## 2024 GROUP A PROPOSED CHANGES TO THE I-CODES

April 7 – 16, 2024  
Doubletree by Hilton  
Universal Orlando - Orlando, FL

# 2024 GROUP A – PROPOSED CHANGES TO THE INTERNATIONAL PLUMBING CODE

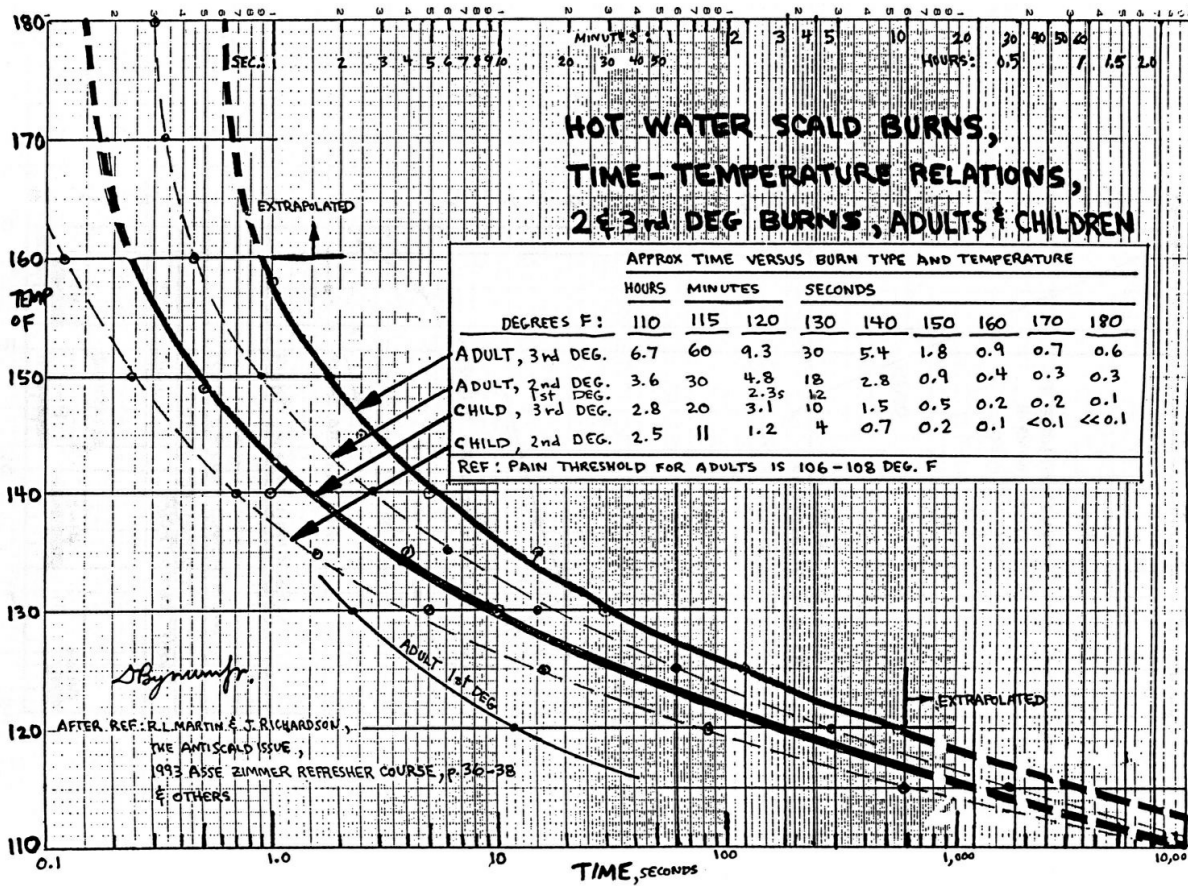
**Reason:** The code language prohibiting use of the water heater thermostat for final temperature control at fixtures is code language that has a long history and purpose in the plumbing codes, and it was mistakenly removed in previous code cycles.

The current language in these sections does not expressly prohibit the use of the water heater thermostat for final temperature at fixtures, and this is necessary to emphasize in order to protect against scalding at fixtures.

The standard for combination gas controls (thermostats) and the standard for uncirculated, tank-type water heaters (both above 75,000 btu/hr and 75,000 btu/hr or less) do not have tests to address temperature control accuracy for scald protection. It is widely known in the plumbing industry that the combination gas control (thermostat) standard allows a 10-degree variation at the thermostat level, and the water heater standards allow a 20-degree temperature differential from the thermostat level, inserted near the bottom of the tank, to the top of the water heater tank.

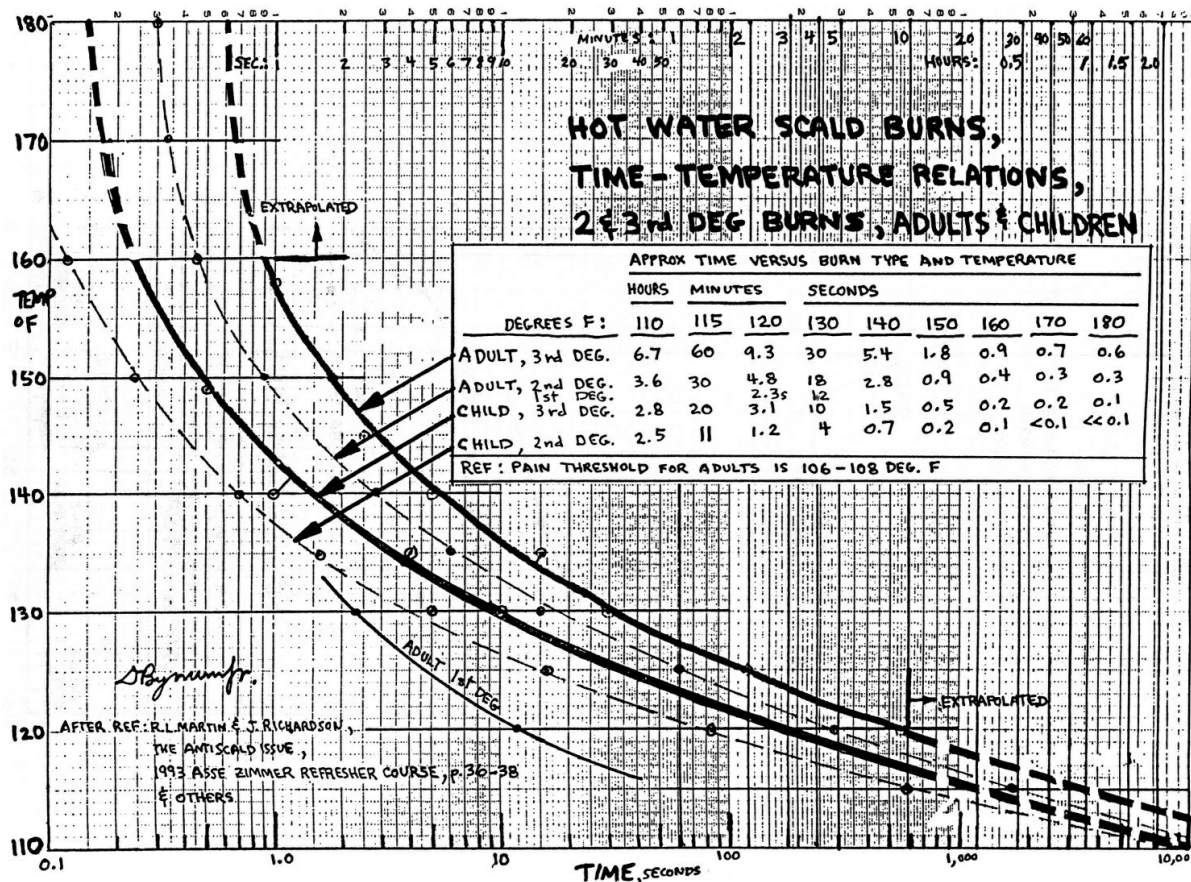
**Reason:** This code change lowers the maximum allowable shower and bathing temperature from 120 F to 115 F to improve safety. The table below extracted from the Moritz & Henriques Burn Studies shows that at 115 F it significantly increases the amount of time for a bather to get out of harm's way before a serious, irreversible, blistering 2nd degree burn injury occurs.

As you can see, 120 F only gives an adult male 4.8 minutes to get out of harm's way and before a serious burn injury occurs. Women, children & infants have thinner skin and can be burned in a much shorter time (1.2 minutes) when exposed to 120 F. Also a bathtub can be filled with 115 F water with heat loss during filling for a comfortable bath at around 102 - 105 F. Therefore, lowering the maximum allowable shower temperature to 115 will provide an increased level of safety for bathing and showering fixtures. The hot water delivery temperature to the shower valve or tub-shower valve can still be higher to control bacteria in the hot water distribution temperature and the maximum temperature limit stop is adjusted to a lower delivery temperature from the shower head or tub filler faucet.

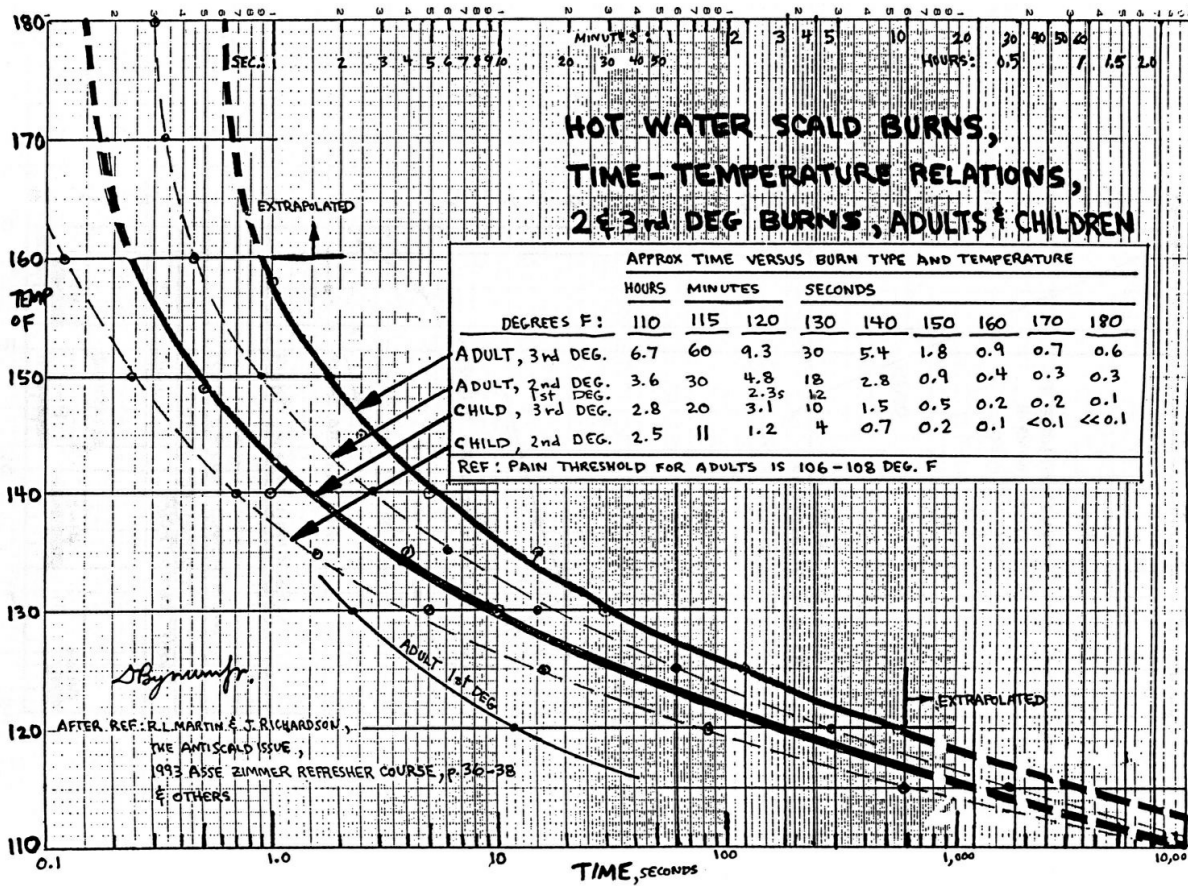
**Reason:** Having a maximum temperature limit of 120 F on a gang shower with a single delivery temperature is unsafe.

This code change simply gives a temperature setting range within a comfortable bathing temperature. Studies of bathing temperatures have shown showering temperatures generally range between 102 to 109 F. Setting the gang shower mixing valve to 105 F with a tolerance of 5 degrees above or below seems like a good and safe temperature requirement. Temperatures above 115 were painful in the Moritz & Henriques Burn Studies. This code change proposes 105 F plus or minus 5 degrees F. The second part of the code change lowers the maximum allowable shower temperature from 120 F to 115 F. The table below extracted from the Moritz & Henriques Burn Studies shows that at 115 F it significantly increases the amount of time for a bather to get out of harm's way before a serious, irreversible, blistering 2nd degree burn injury occurs.

As you can see, 120 F only gives an adult male 4.8 minutes to get out of harm's way and before a serious burn injury occurs. Women, children & infants have thinner skin and can be burned in a much shorter time (1.2 minutes) when exposed to 120 F. Also a bathtub can be filled with 115 F water with heat loss during filling for a comfortable bath at around 102 - 105 F. Therefore, lowering the maximum allowable shower temperature to 115 will provide an increased level of safety for bathing and showering fixtures.

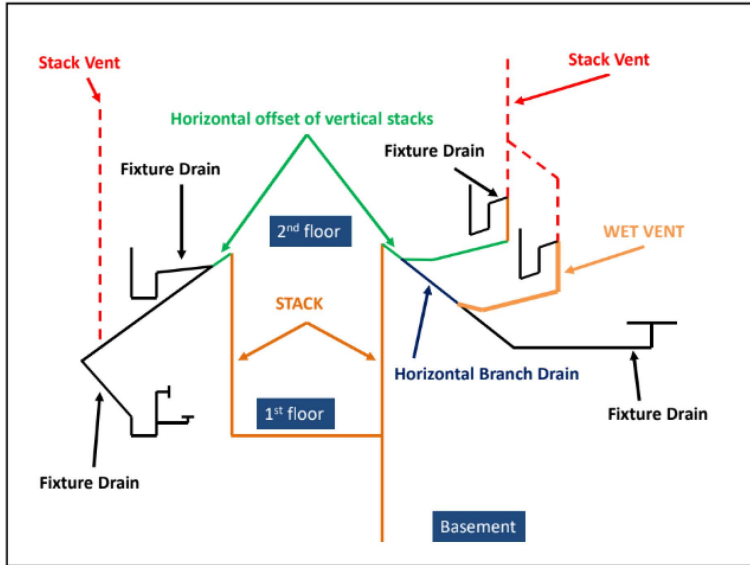
**904.2.1 Stack vent required.** Each soil or waste stack shall be provided with a stack vent at the interconnection between the stack and the uppermost drainage connection to the stack.

**904.2.2 Vent stack required.** A vent stack shall be required for every drainage stack that has five branch intervals or more.
